COLORADO

Parks and Wildlife

Addendum No. 1 - 4/9/25
Rifle Falls SFU – Isolation Building

PLUMBING PLAN

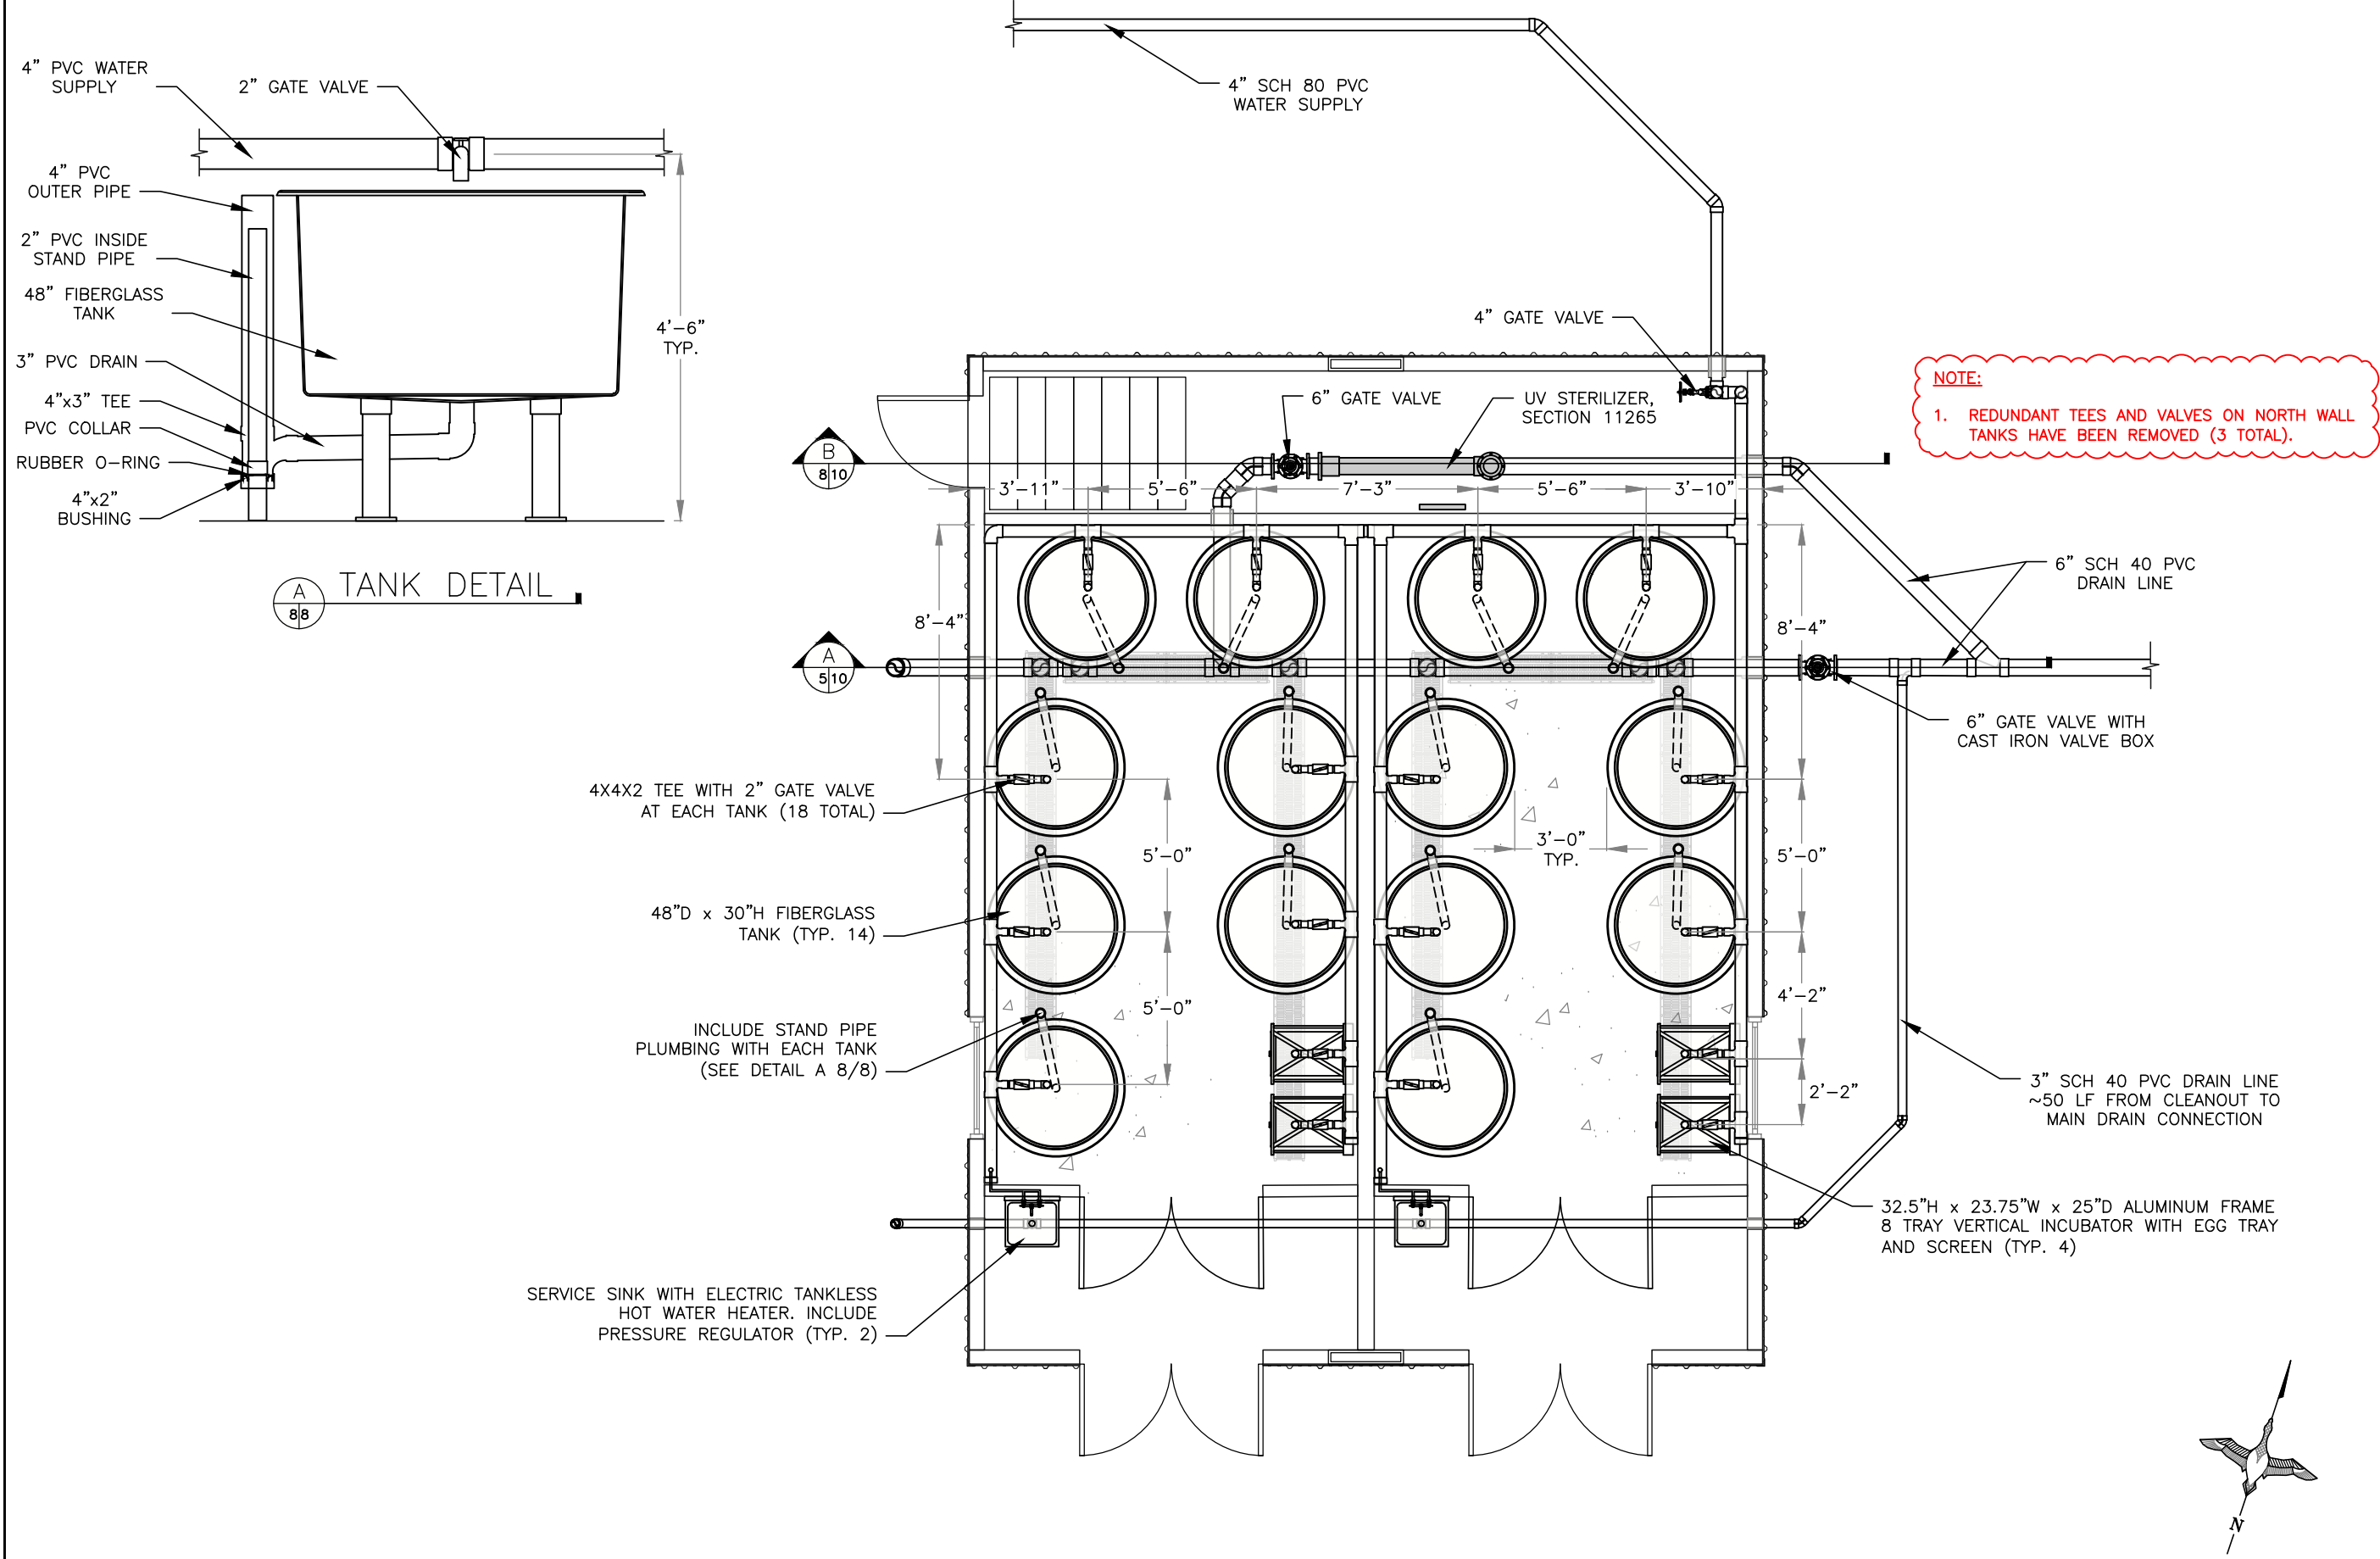
REMOVE: REDUNDANT TEES AND VALVES ON NORTH WALL TANKS (3 TOTAL).

NOTE:
1. REDUNDANT TEES AND VALVES ON NORTH WALL
TANKS HAVE BEEN REMOVED (3 TOTAL).
